Project	IEEE 802.16 Broadband Wireless Access Working Group < <a href="http://ieee802.org/16">http://ieee802.org/16</a> >	
Title	Inter-Sector HO scenario	
Date Submitted	[2004-05-07]	
Source(s)	Sohyun Kim Yeongmoon Son Jungje Son Changhoi Koo  Samsung Elec. 416, Maetan-3dong, Youngtong-gu Suwon-si, Gyeonggi-do Korea	Voice: +82-31-279-5091 +82-31-279-5091 Fax: +82-31-279-5130 +82-31-279-5130  <a href="mailto:binde.kim@samsung.com">binde.kim@samsung.com</a> <a href="mailto:ym1004.son@samsung.com">ym1004.son@samsung.com</a> <a href="mailto:jungje.son@samsung.com">jungje.son@samsung.com</a> <a href="mailto:chkoo@samsung.com">chkoo@samsung.com</a>
Re:	This document is the reply of the call for contribution IEEE802.16e/D2-2004	
Abstract	This proposal is about Sector handover considering movement to the other sector in the same cell according to the sector architecture of 802.16d.	
Purpose	Propose the sector HO scenario, method and enhanced management message using sector architecture of 802.16d for the IEEE802.16e Handoff Ad hoc group

## Inter-sector HO scenario

**Figure E.14—Example Intersector HO process by MSS's request and decision of Target BS**

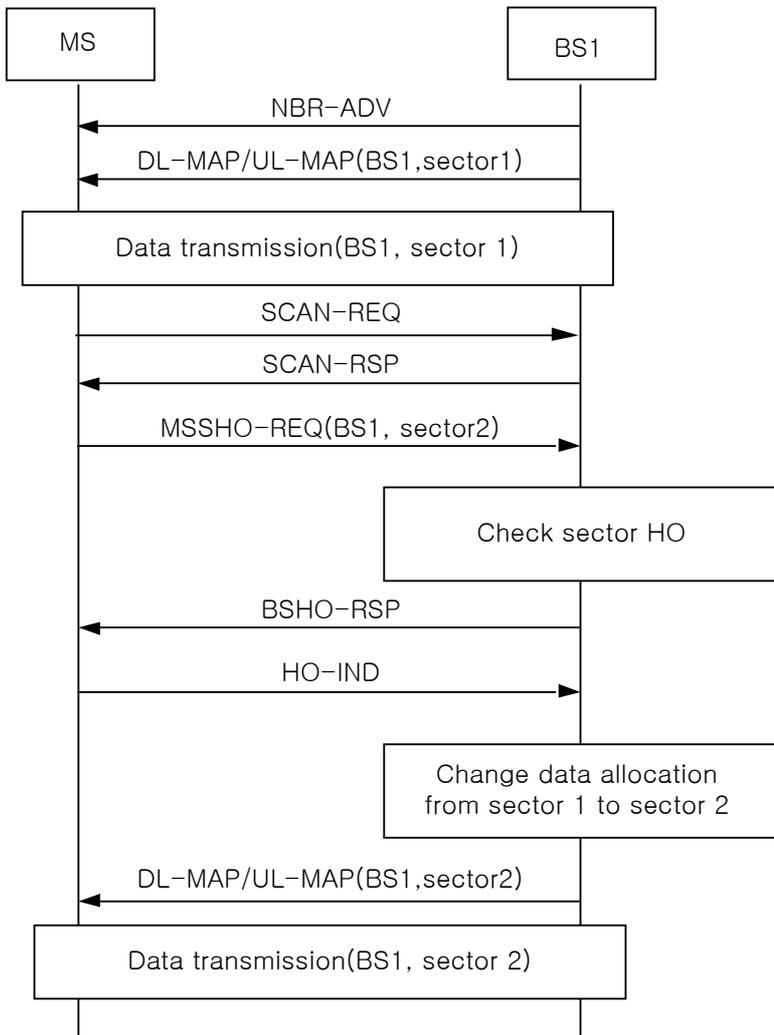
*[Insert the following scenario at the end of Figure E.13]*

**Figure F.7—InterSector HO process block diagram in BS by MSS request**

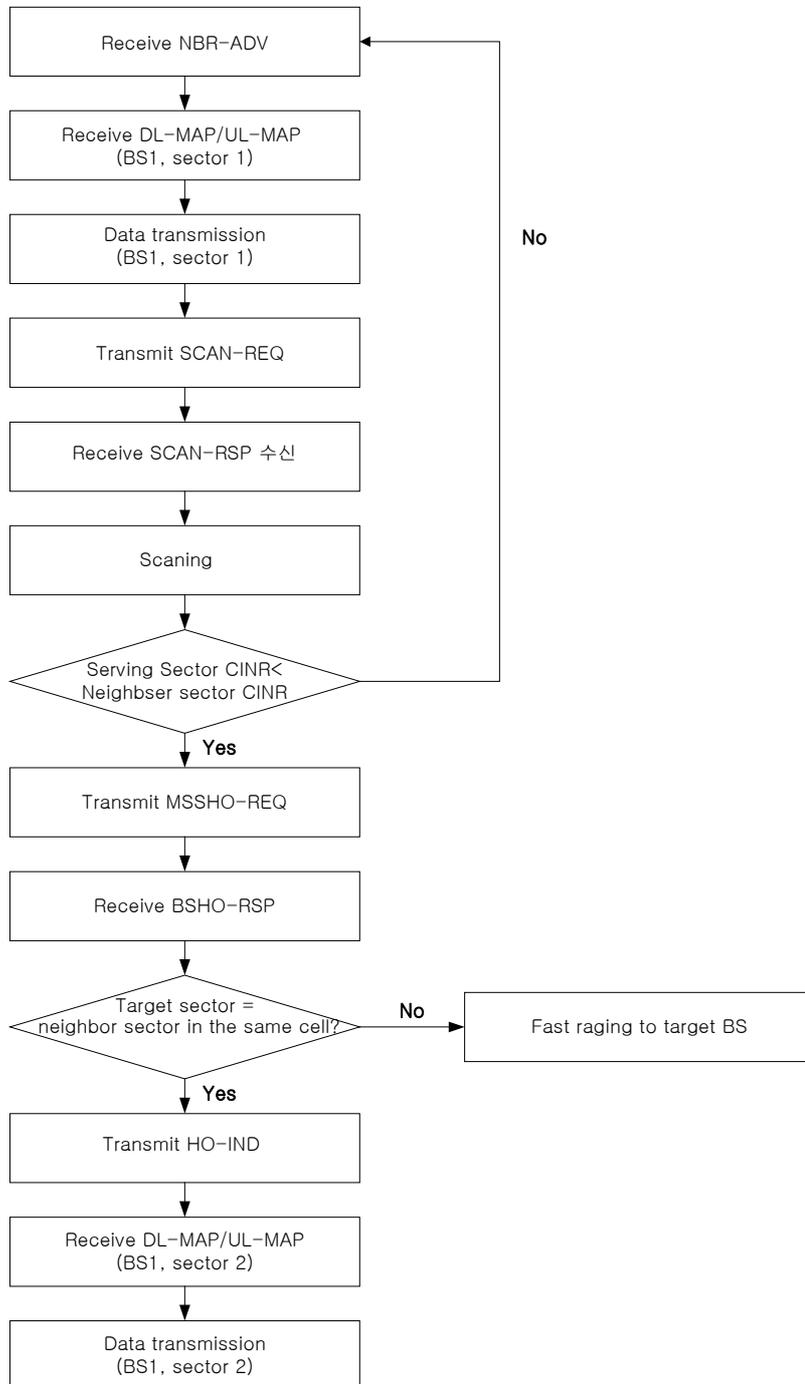
[Insert the following scenario at the end of Figure F.5]

**F.1.3 Intersector Handover by MSS request**
